# FLORENCE COUNTY PLANNING COMMISSION MEETING

PC#2013-12

Request for Sketch Plan approval for West Lake Phase II Subdivision **Subject:**

### PC# 2013-12 Sketch Plan

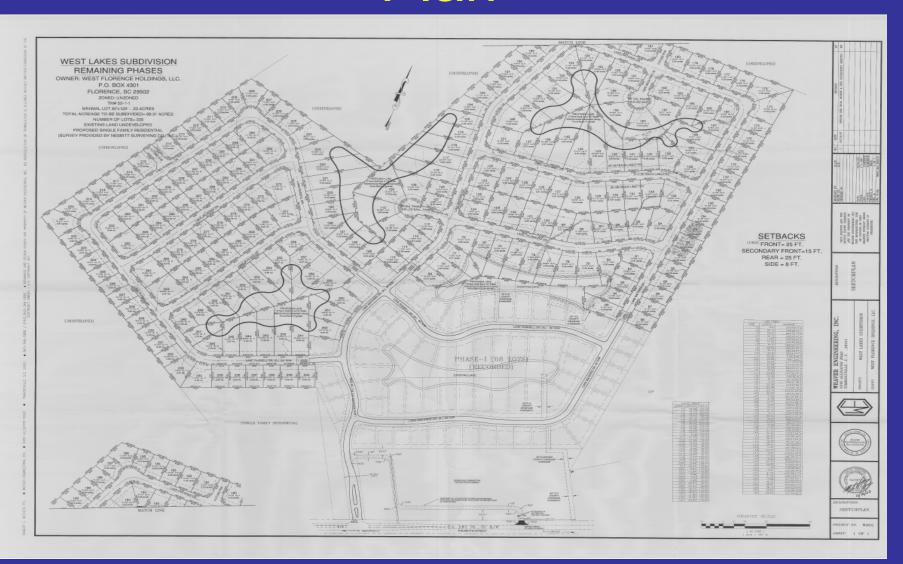
Staff notified the subdivder, in writing, on August 16<sup>th</sup>, 2013 that the plan review had been completed and the Staff determined that the sketch plan, with minor changes, will conform with the applicable codes and ordinances.

Staff does not recommend granting the variance request to exempt the subdivider from the sidewalk requirement of Section 28.6-77 because staff cannot find physical conditions that exist that would prevent the installation of sidewalks and no alternate means of pedestrian access and movement have been provided or proposed by the subdivider in lieu of meeting the sidewalk requirement.

Staff does not recommend granting the variance request to meet the alternate requirement for street trees outlined in Section 28.6-70 (b) (3) via adoption of restrictive covenants for Phase II of the proposed subdivision. Restrictive Covenants apply to the end user of the individual properties and does not meet the standards set for subdivision completion by a subdivider/developer prior to recordation of a final plat for sale to an end user.

- The Subdivider shall include sidewalks in the development plan submittal.
- The Subdivider shall include a Site Plan and Subdivision Landscaping Design in conformance with Chapter 28.6, 28.6-70 (b) (3) or conform with Section 28.6-70, Street Trees requirements in the development plan submittal.
